November 20, 2015

Fr: Donna Gilmore dgilmore@cox.net 949-204-7794
SanOnofreSafety.org

Re: Docket ID NRC-2015-0241 Draft SFM-Interim Staff Guidance (ISG)-2, Revision 2, "Fuel Retrievability in Spent Fuel Storage Applications"

Figure 20. Cladding Outer Surface Oxide Layer Thickness versus Rod Average Burnup

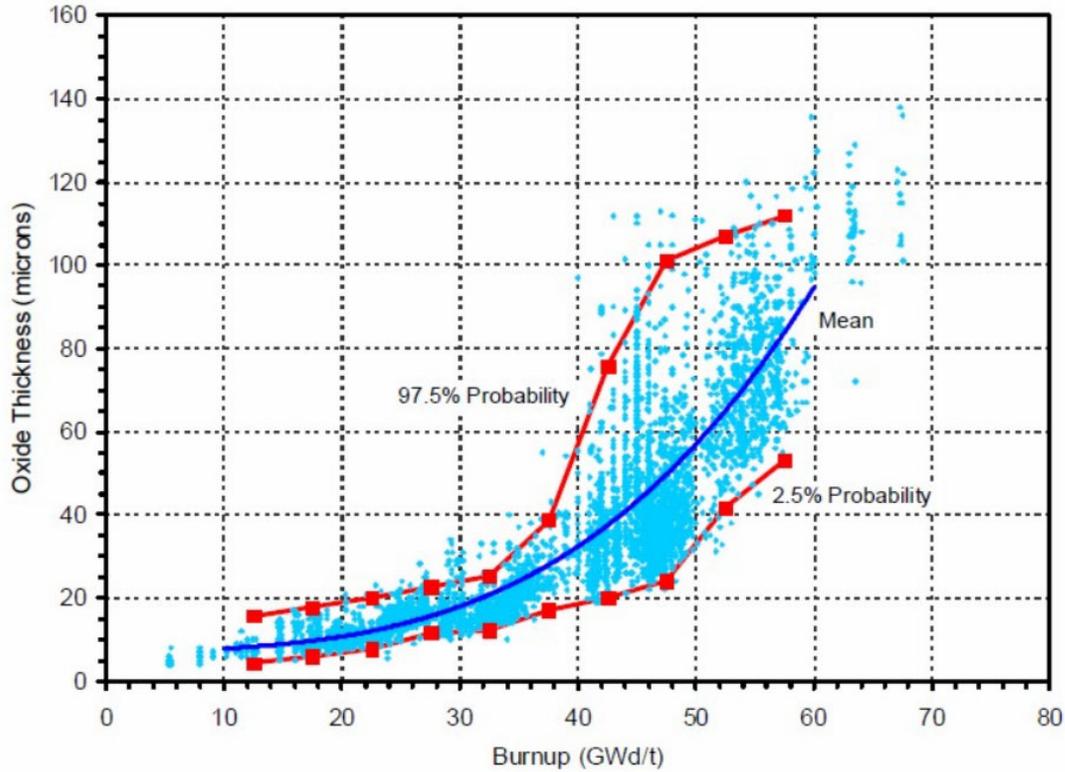
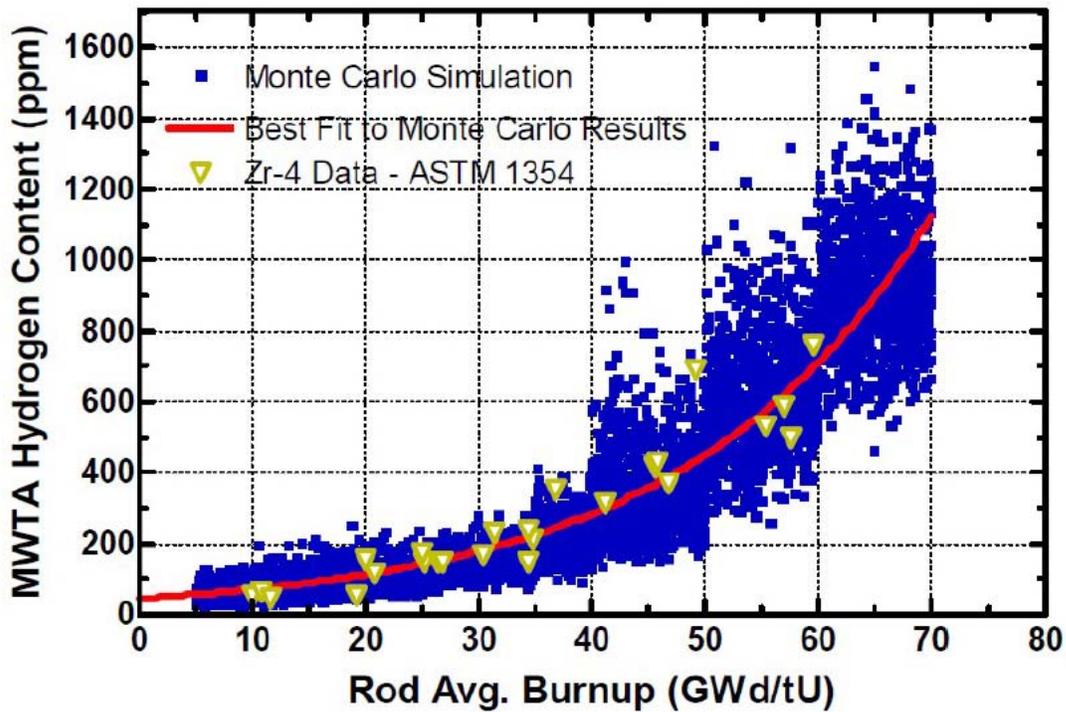
- **Data from high burnup fuel rods shows increased oxide thickness with increased burnup.** Page 55 and 60 of NWTRB report states: “Hydride precipitation can be evenly distributed or dominate in certain areas. Both cladding hydrogen content and effective wall-thickness are correlated to the amount of oxidation that occurs on the outer surface of the cladding. Plotting more than 4,400 measurements from commercial fuel-rods taken from reactors around the world, Figure 20 shows the maximum outer-surface oxide-layer thickness data in low-Sn Zircaloy-4 cladding plotted as a function of burnup.

Taking these oxide thickness measurements, the maximum wall thickness average (MWTa) hydrogen content can be calculated using a hydrogen evolution model. Figure 21 plots the wall-average hydrogen content in low-Sn Zircaloy-4 cladding as a function of burnup from both measured and model-calculated data. For a discharge burnup in the range of 60-65 GWd/MTU, the maximum oxide thickness is 100 μm and the average hydrogen concentration is 800 ppm, which corresponds to a metal loss of 70 μm using conservative assumptions.”

See Figure 20 and 21 on next page.
